UNITED STATES PATENT AND TRADEMARK OFFICE

APPLICATION NO.	FILING DATE	FIRST NAMED INVENTOR	ATTORNEY DOCKET NO.	CONFIRMATION NO.
10/631,230	07/31/2003	George C. Lackey	74123-001	1726
29493	7590	07/16/2004		
HUSCH & EPPENBERGER, LLC 190 CARONDELET PLAZA SUITE 600 ST. LOUIS, MO 63105-3441		EXAMINER THOMSON, MICHELLE R		
		ART UNIT 3641		PAPER NUMBER

Office Action Summary	Application No.	Applicant(s)	
	10/631,230	LACKEY, GEORGE C.

DETAILED ACTION

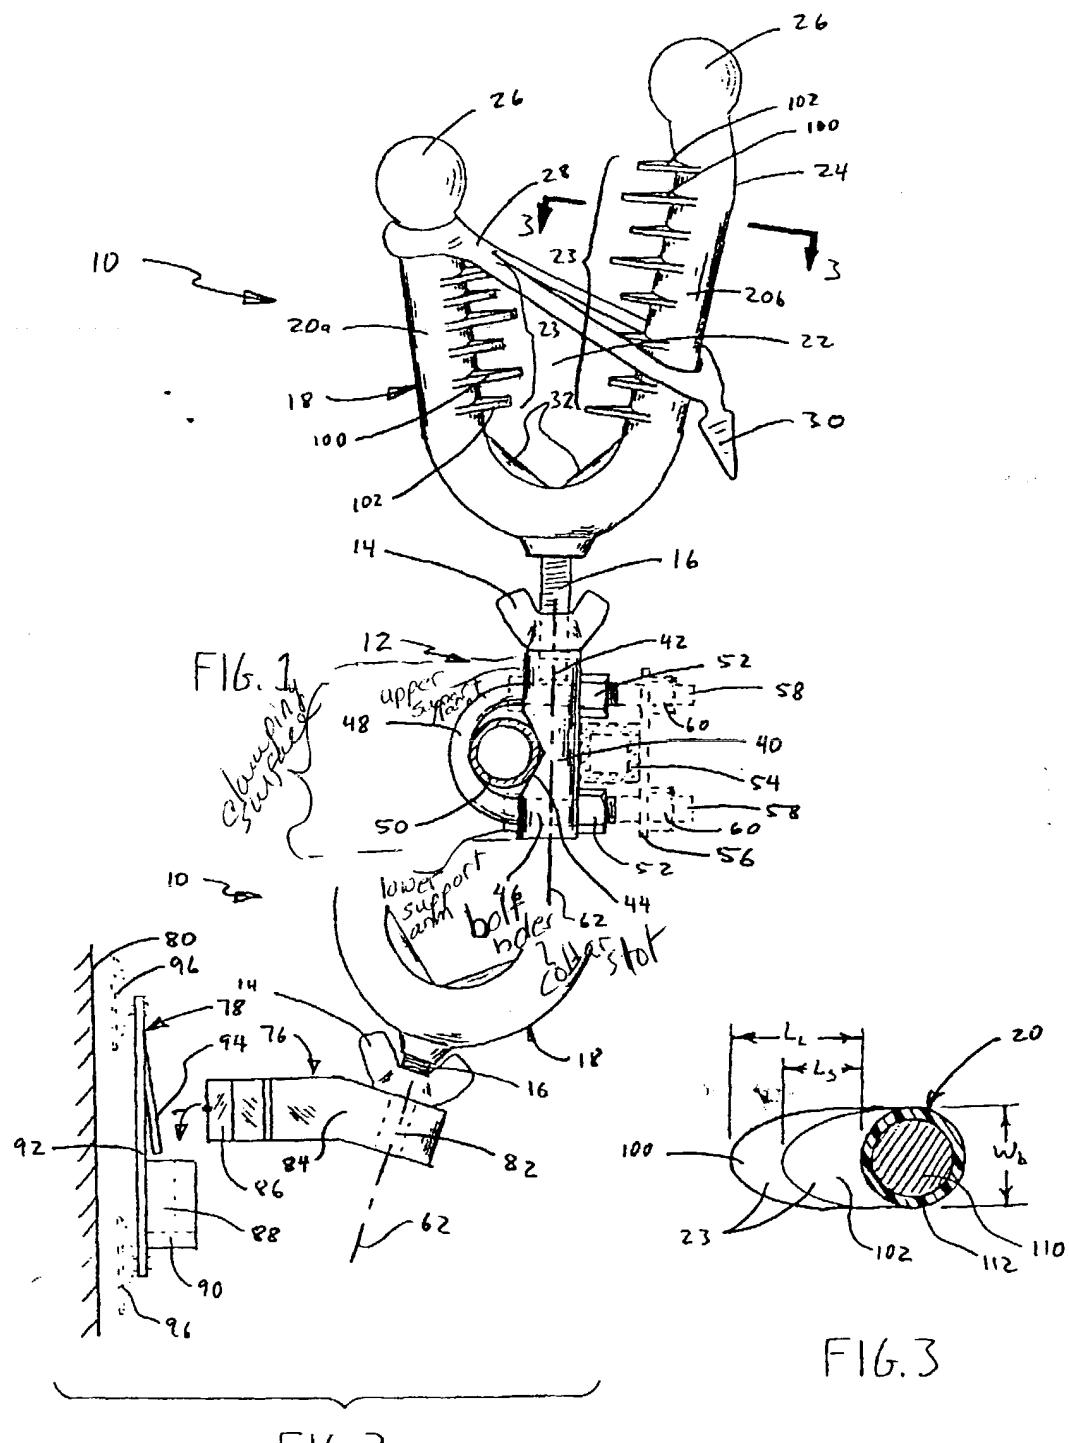
9. Claims 1, 2, 4-6, and 8-11 are rejected under 35 U.S.C. 102(e) as being anticipated by Gates et al. (US Patent # 6,588,637). Gates et al. discloses a supporting apparatus for attaching to various structures, the apparatus comprising an elongated support (reference 10) member having a concave (reference 44) clamping surface (reference 40) and a contoured (reference 18) firearm supporting surface comprising a concave cradle (reference 32) that is covered by a flexible material with a non-skid surface (reference 23) (column 2, lines 45-55); an u-bolt (i.e. collar) (reference 48) connected with the elongated support member; and an adjustable mechanism (nuts 52 and the threaded ends of u-bolt 48) connecting the collar with the elongated support member and adjusting the position of the collar relative to the clamping surface of the support member (column 3, lines 44-55), the collar and clamping surface securing the support member to a shaft (reference 50). The adjustable mechanism includes an elongated threaded member (column 3, lines 50-56) connected with the collar and the elongated support member and a fastening device (reference 52) associated with the threaded member, wherein tightening and loosening the fastening device on the threaded member adjusts the position of the collar relative to the clamping surface. The clamping surface includes upper and lower support arms

and the support member defines bolt holes (i.e. a collar slot) (reference 46) separating the upper and lower support arms (see examiner's notes on figure 1).
